MANDATORY BULLETIN

N° BO 13/99

NAME - TYPE / MODEL: MDM-1 „Fox”

CONCERNS: Enlarging of removable balancing weight and revision to rear limit of allowed C.G. position of empty glider (which results in necessity of permanent correction weight installation on MDM-1 FOX type gliders).

4.1. Correction of removable balancing weights' mass:

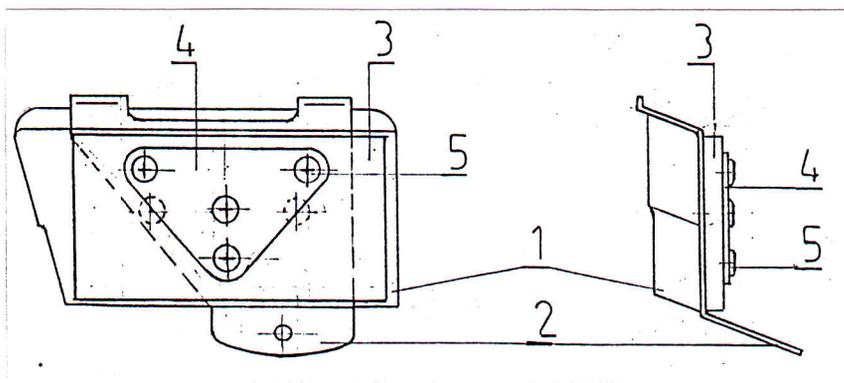
Necessary modification includes enlarging mass of removable balancing weights, required while flying with lightweight crew. These are changed from 8.5 kg to 11.0 kg by installation of two segments, weighing 1.25 kg each.

- 1- existing ballast
- 2- existing ballast's fastening plate
- 3- lead plate
- 4- steel cap
- 5- screws

- place lead plate (3), together with steel cap (4) over existing ballast (1). After adopting these to match each other, drill 4 holes through the lead of existing ballast and its fastening plate. Use the new steel cap together with lead plate to pilot the newly drilled holes;

NOTE: DRILL CAREFULLY IN LEAD; APPLY LUBRICANT ON THE DRILL

- after the holes are drilled, fasten the whole set with 4 screws (5).
- The manufacturer supplies with this Bulletin: additional balancing weights, steel caps, drill, 12 screws (including 4 spare ones).

4.2. Correction of empty glider C.G. location:

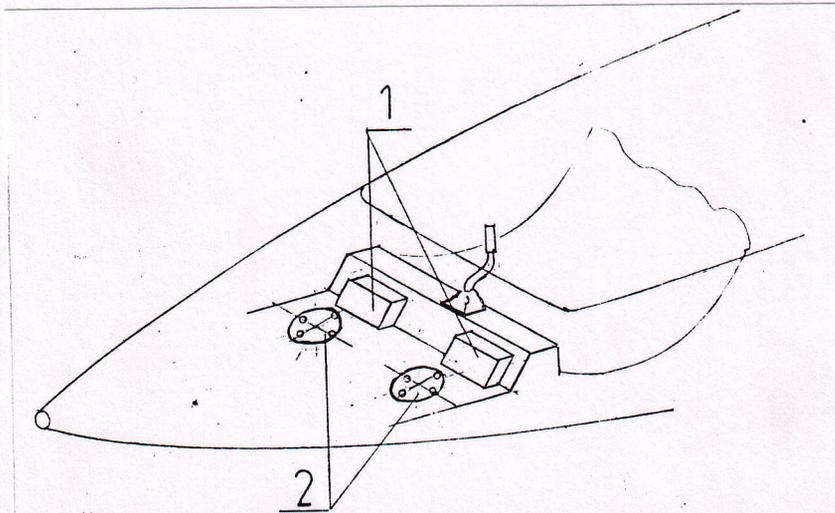
Additionally, in gliders with Factory Nos. P-15, P-16, 205, 206, 209, 212, 213, 214, 216, 217, 218, 219, 220, 221, 221, 222, 223, 225, covered with this Bulletin, it is necessary to introduce a permanent weight of 1 to 3,5 kg - depending on particular glider. This ballast should be installed inside one of two intended for this purpose chambers, located in front of the front seat, below location of removable balancing weights installation.

1- removable ballast
2- ballast chambers
covers

- unscrew 4 screws fastening ballast chamber cover, and remove the cover;
- place bag with lead shots (correction weight) inside ballast chamber;
- in order to prevent the ballast from moving inside the chamber, fill remaining empty space tightly with foamed polystyrene granulate supplied with Bulletin;
- place and screw the cover on.
